Brockville Solar Project Renewable Energy Approval Modification Report

Final Report

June 3, 2025

Project Number:
161414291

Appendix D Stormwater Management Report

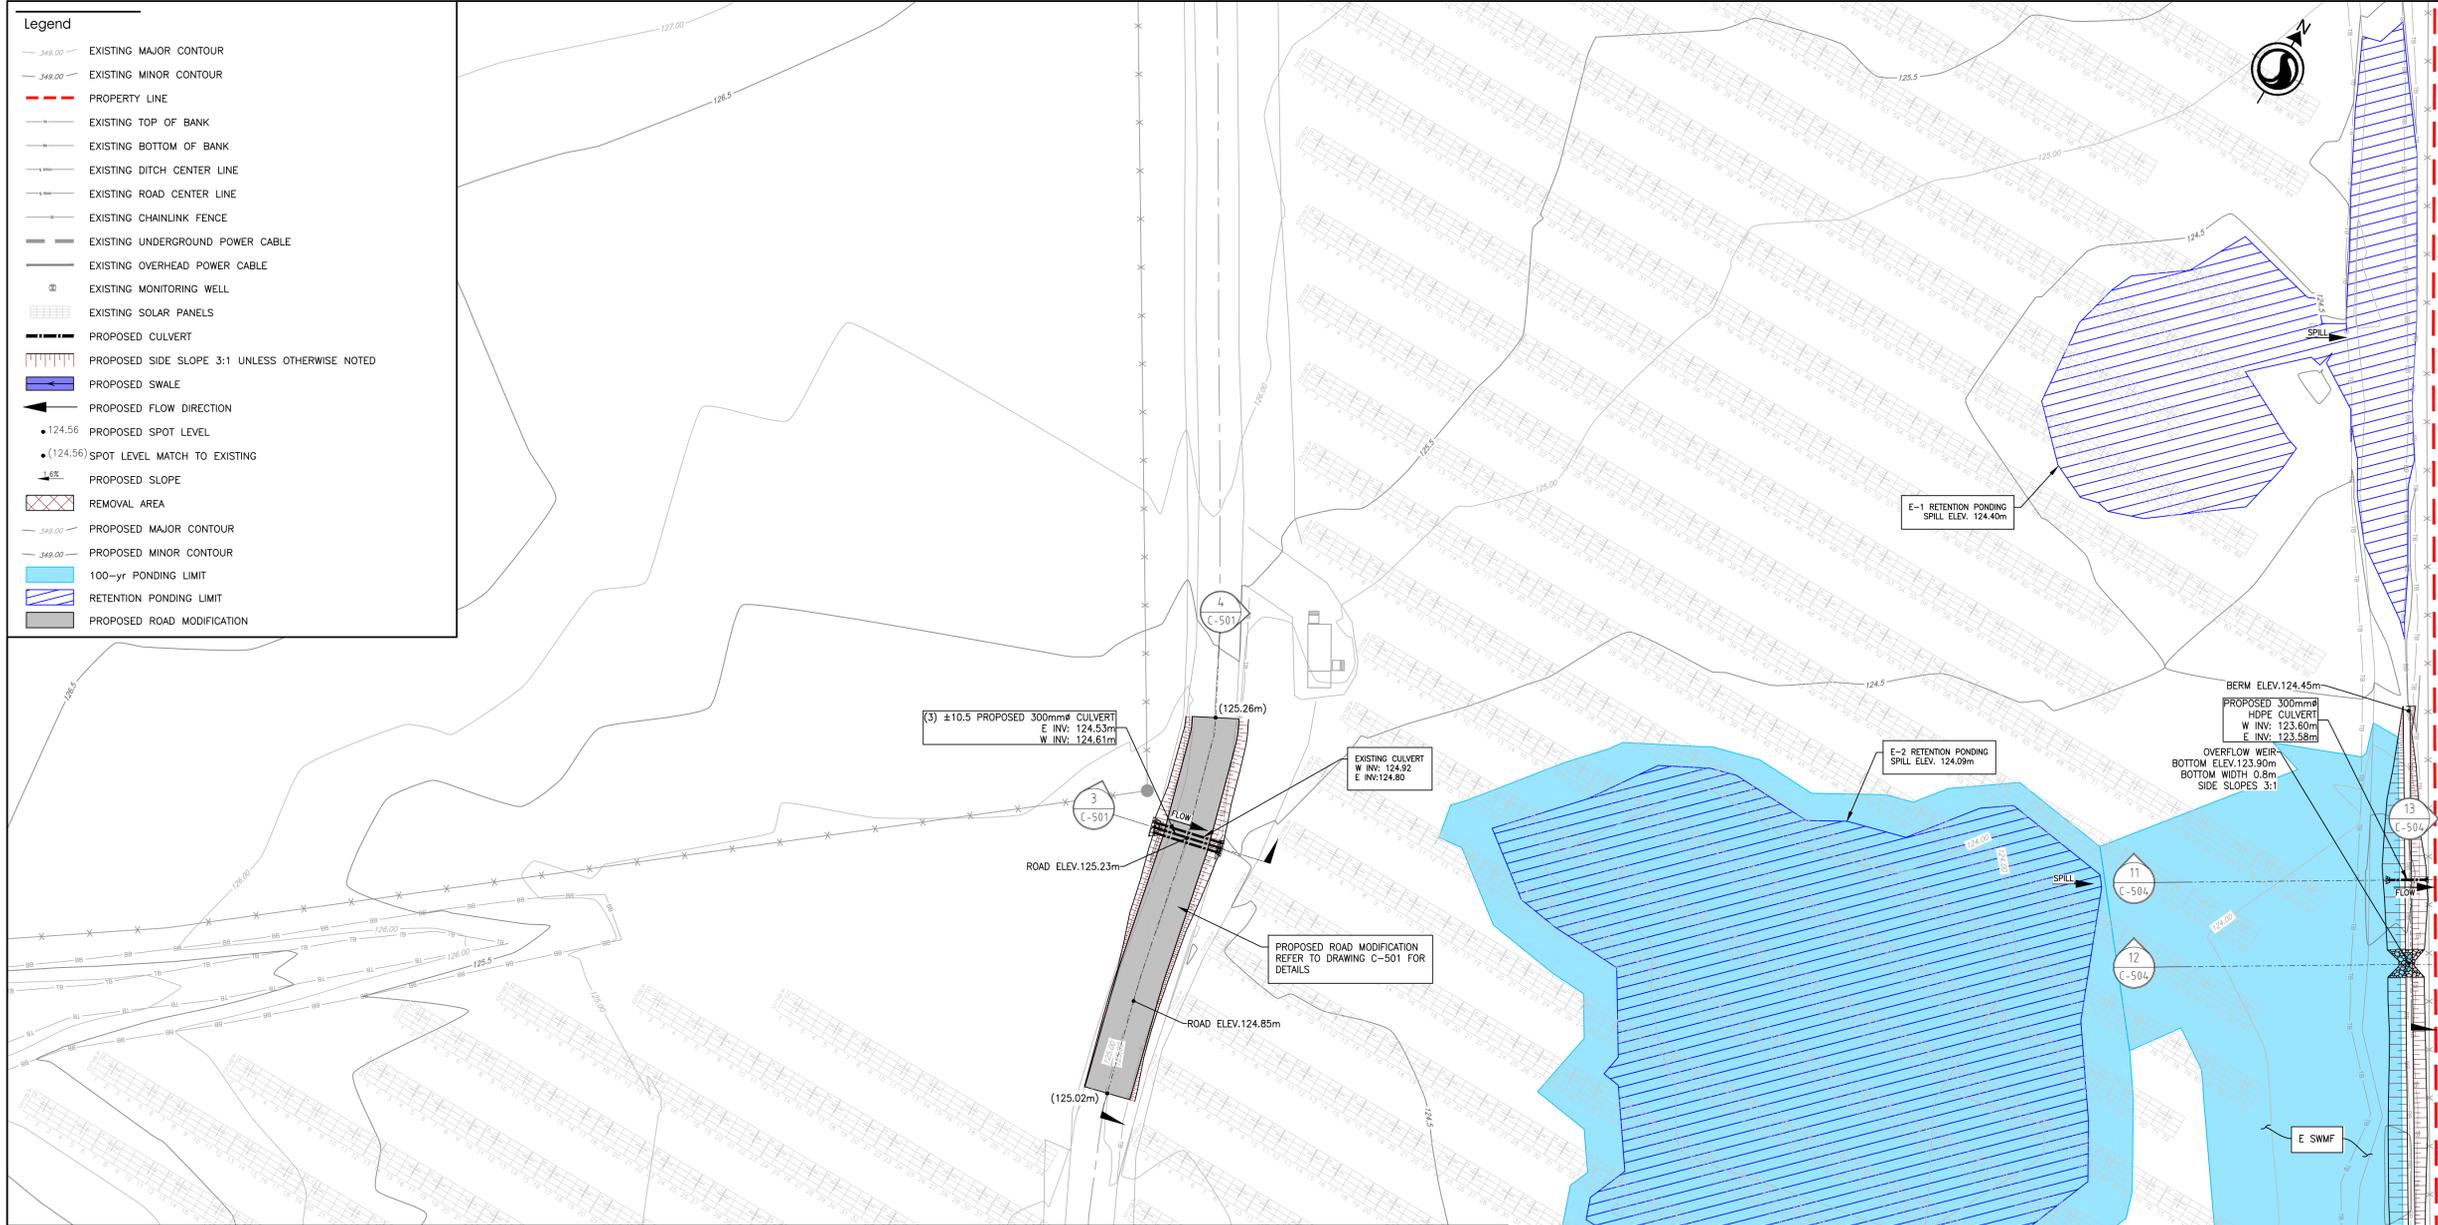
To support the technical change, an updated SWM design completed by Stantec (Appendix D) will aim to reduce the use of any excavated materials by using a combination of berms and outlet controls to provide shallow detention basins that will provide on-site water quantity control for the Project.

The original site plan can be found in Appendix B, followed by the revised site plan with the proposed changes in Appendix C.

The proposed technical change is an updated SWM design aimed to modify the approved stormwater management plan by reducing need for significant excavation and using a combination of berms and outlet controls to provide the required water quantity control for the Project. The proposed controls will all be along the perimeter of the site and in the Project Property Line. In addition, there will be the installation of a back-up generator to provide station service support in the event of a power outage where the Project does not receive power from the grid.
